Access Compliance Report

Public Rights-of-Way

(Curb Ramps)

Intersection ID: 12279	Main Street: S_MINT_ST	Cross Street: W_MARTIN_LUTHER_KING_JR_BV	Location: S
ADA ID: EC45F2D8D112	Ramp Type: Perp	Initial Pass/Fail: Fail	Overall Compliance: No
Severity Score: 8.75			
Codes/Mitigation Info/Possible Solution		Field Measurements/Component Compliance

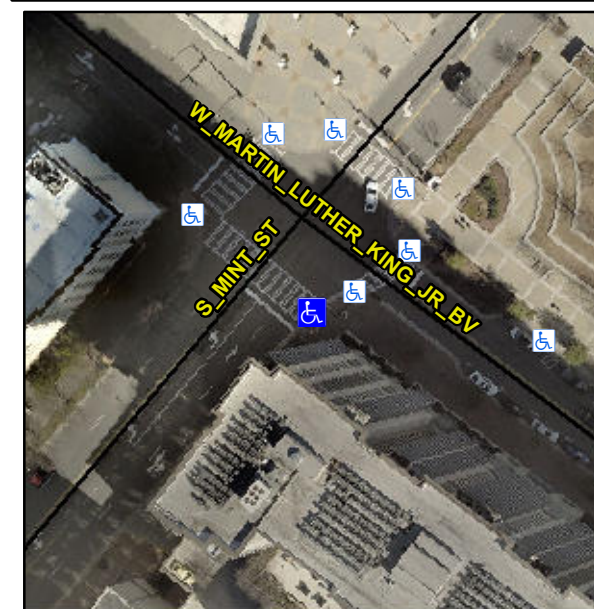
R304.5.1

Compliance	Description	Data	Compliance	Description	Data
N/A	Ramp Length (in)	54.0	Yes	Ramp Slope (%)	6.1
No	Ramp Width (in)	47.0	Yes	Ramp XSlope (%)	1.4
N/A	Flare Type LT	N/A	N/A	Flare Type RT	N/A
N/A	Flare Slope LT (%)	N/A	N/A	Flare Slope RT (%)	N/A
N/A	Flare Traversable LT?	N/A	N/A	Flare Traversable RT?	N/A
N/A	Landing Length (in)	N/A	N/A	DWS Provided?	N/A
N/A	Landing Width (in)	N/A	N/A	DWS Contrast?	N/A
N/A	Landing Slope (%)	N/A	N/A	DWS Length (in)	N/A
N/A	Landing X Slope (%)	N/A	N/A	DWS Full Width?	N/A
N/A	Landing Curb? (Y/N)	N/A	N/A	DWS Offset (in)	N/A
N/A	Shared Landing?	N/A			
N/A	Gutter Ponding?	N/A	N/A	Gutter Slope (%)	N/A
N/A	Gutter Lip Ht (in)	N/A	N/A	Gutter X Slope (%)	N/A
N/A	Painted X Walk1?	Yes	N/A	Painted X Walk2?	N/A
	X Walk 1 Direction	To NW		X Walk 2 Direction	N/A
N/A	X Walk 1 Width (in)	172.0	N/A	X Walk 2 Width (in)	N/A
	X Walk 1 Slope (%)	1.4		X Walk 2 Slope (%)	N/A
	X Walk 1 X Slope (%)	2.9		X Walk 2 X Slope (%)	N/A

N/A	Ramp inside XWalk1?	Yes	N/A	Ramp inside XWalk2?	N/A
	Road Slope (%)	N/A	N/A	Clear Space?	N/A
	Road X Slope (%)	N/A	N/A	Clear Space to XWalk (in)	N/A
N/A	Any Obstructions?	N/A	N/A	Storm Grate/Utility Hazard?	N/A
	Obstruction Type			Storm Grate/Utility Type	
		N/A			N/A
			Yes	Surface Condition? (G/P)	Good

Remove & Replace Entire Ramp.
